# febi 28798, 30167, 40717

Fiat Ducato II, III; Iveco Daily III, IV, V and VI

Engine: 2.3-litre JTD F1AE

## Air Conditioning Compressor Auxiliary Drive Belt

**Fig 1** - Auxiliary drive diagram (up to and including engine No. 0113089), fitted with tensioner pulley 30167 and multi V-ribbed belt 28798.

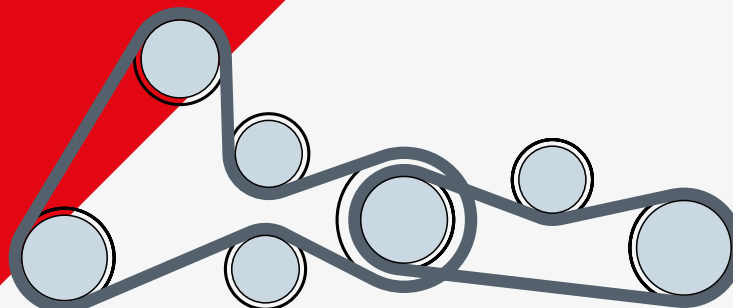
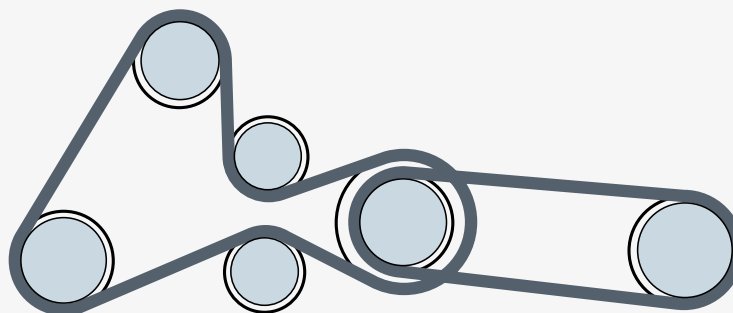
During the production period, Fiat and Iveco updated the layout routing and size of the auxiliary drive belt for the air conditioning compressor. This is applicable on several models fitted with the 2.3-litre JTD engine, starting from engine No. 0113090.

The update completely removed the requirement for the tensioner pulley used with the conventional 987 mm multi V-ribbed belt, fitted up to and including engine No. 0113089. (Fig1)

This was replaced with a shorter 903 mm elastic multi V-ribbed belt, which is routed as per the diagram above. (Fig2)

Note: for vehicles fitted with engines up to and including engine No. 0113089, this can also be retrofitted with the elastic multi V-ribbed belt 40717 during routine maintenance. This eliminates the requirement for the tensioner pulley altogether.
